ALERT SERVICE BULLETIN

TRANSMITTAL LETTER
FOR
SERVICE BULLETIN ANMD-27-41 Rev 2

FLIGHT CONTROLS — REVISION OF FLAP AUTO-SELECT SWITCH SYSTEM (MOD N46)

FLIGHT CONTROLS — REVISION OF FLAP AUTO-SELECT SWITCH SYSTEM (MOD N46)

Figure 1 Flap Microswitch Assembly — Installation

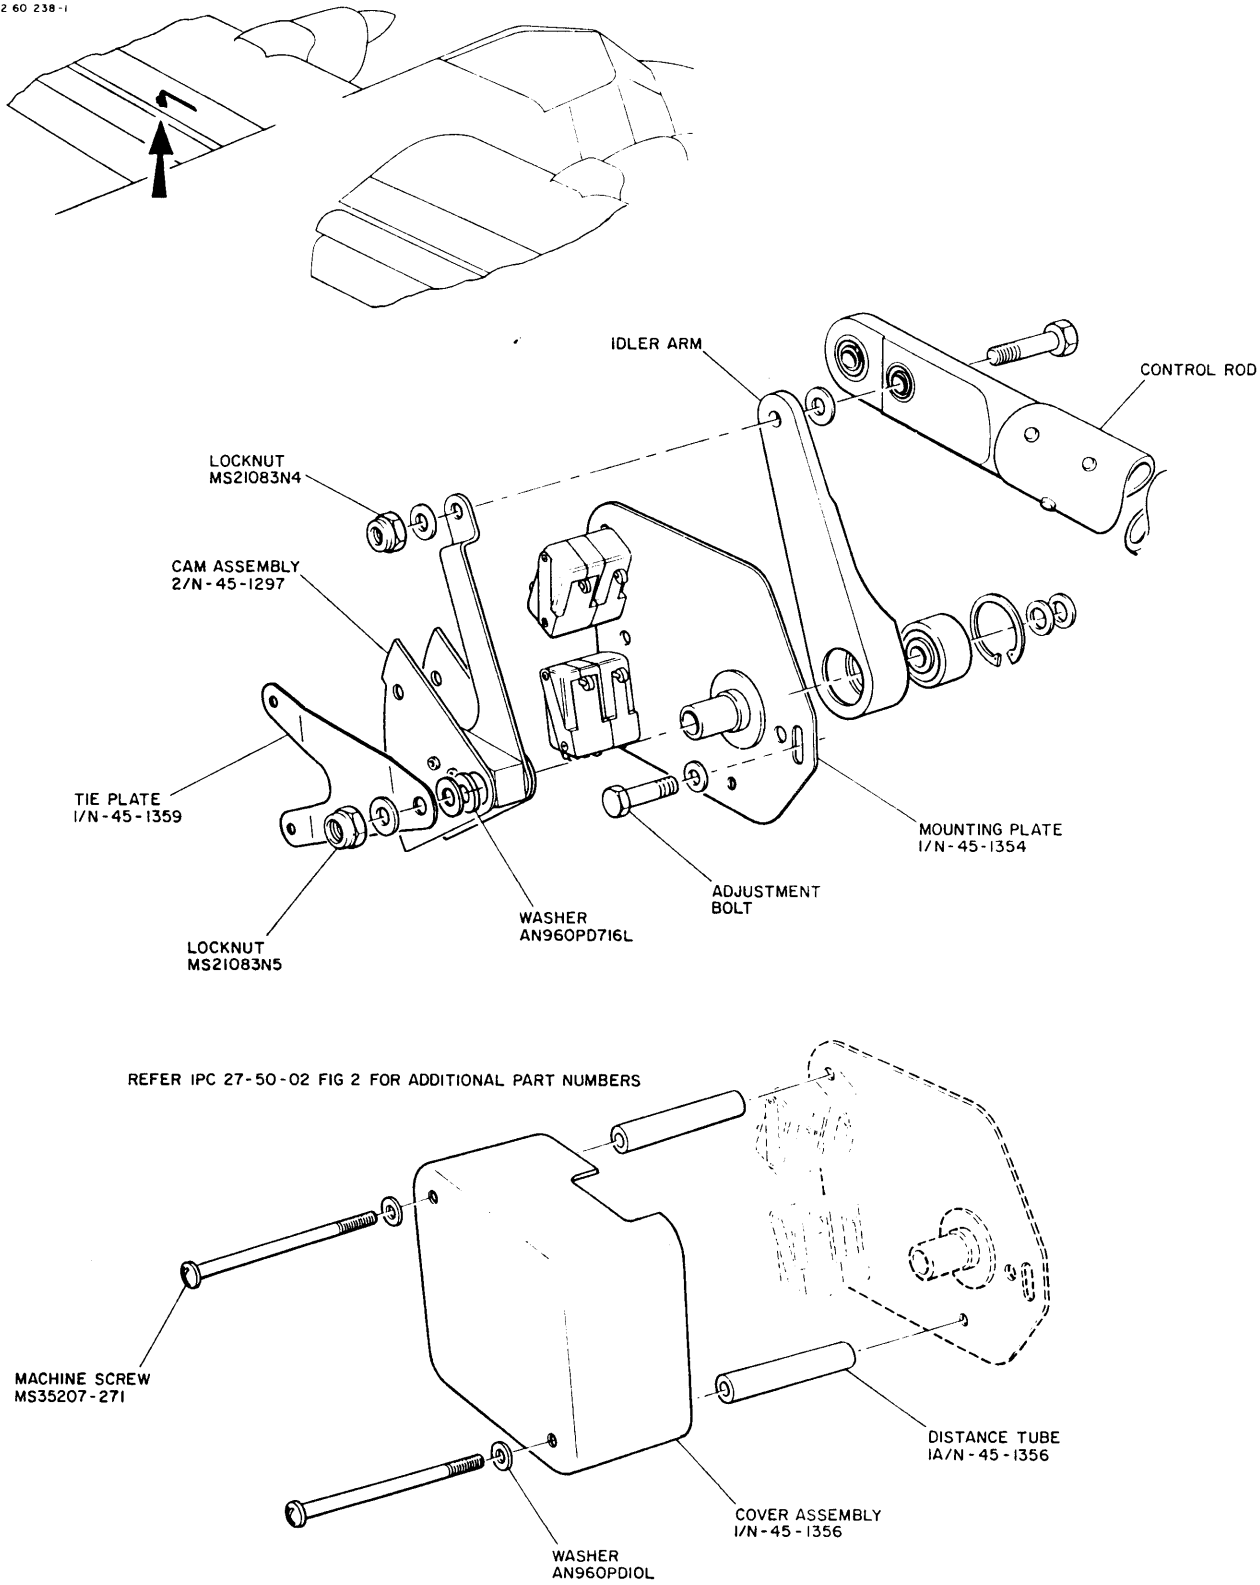
A revised cam is fitted for the stall warning and landing gear switches and a new mounting plate is provided which permits the fitting of a cover.

- A. Extend the flaps to the landing position as detailed in MM 27-50-00, observing all safety procedures.
- B. Open the trailing edge door to gain access to the microswitch assembly at WSta 62.528.
- C. Remove the securing nuts and washers at the flap idler arm mounting bolt and idler arm to control rod connection. Remove the tie plate and cam assembly (Ref Fig 1).

- D. Remove the screws, washers and nuts securing the microswitches and actuators to the mounting plate.
- E. Remove the mounting plate adjustment bolt and remove and discard the mounting plate 1/N-45-1294.
- F. Assemble microswitches and actuators to mounting plate 1/N-45-1354 with existing screws and washers and new locknuts MS21083N04.
- G. Install the mounting plate on the flaps idler bolt with the mounting plate located centrally within its range of adjustment. Loosely install the adjustment bolt with the washer under the bolt head.
- H. Place the cam assembly 2/N-45-1297 on the flap idler bolt and wet assemble. Depress the microswitch plungers and push the cam fully home. Allow the microswitch actuator rollers to rest on the cam face.

- I. Using a new locknut, install the nut and washers attaching the cam assembly and idler arm to the control rod (Ref Fig 1).
- J. Torque tighten control rod bolt to 30–40 lb in and the flap idler attaching bolt to 60–85 lb in.
- K. Set the battery switch to ON, set the flaps circuit breakers and check the adjustment of the microswitches. Functionally test the operation of the AUTO switch and stall warning system (Ref MM Chap 27–50–00 and 31–52–00).
- L. With all adjustments completed, extend the flaps and install Cover Assembly 1/N–45–1356 over the microswitch and cam assembly (Ref Fig 1).
- M. Check the operation of the landing gear up warning system (Ref MM Chap 32–60–00).
- N. Set the battery switch to OFF, trip the flaps circuit breakers and disconnect the external electrical supply.

New Part No	Qty	Description	Old Part No	Instruction/Disposition
Parts to be obtained from ASTA General Aviation				
2/N–45–1297	1	Assembly, Cam	1/N–45–1297	Scrap
1/N–45–1354	1	Assembly, Mounting Plate	1/N–45–1294	Scrap
1/N–45–1359	1	Plate, Tie	1/N–45–1347	Scrap
1/N–45–1356	1	Assembly, Cover		
AN960PD716L	1	Washer
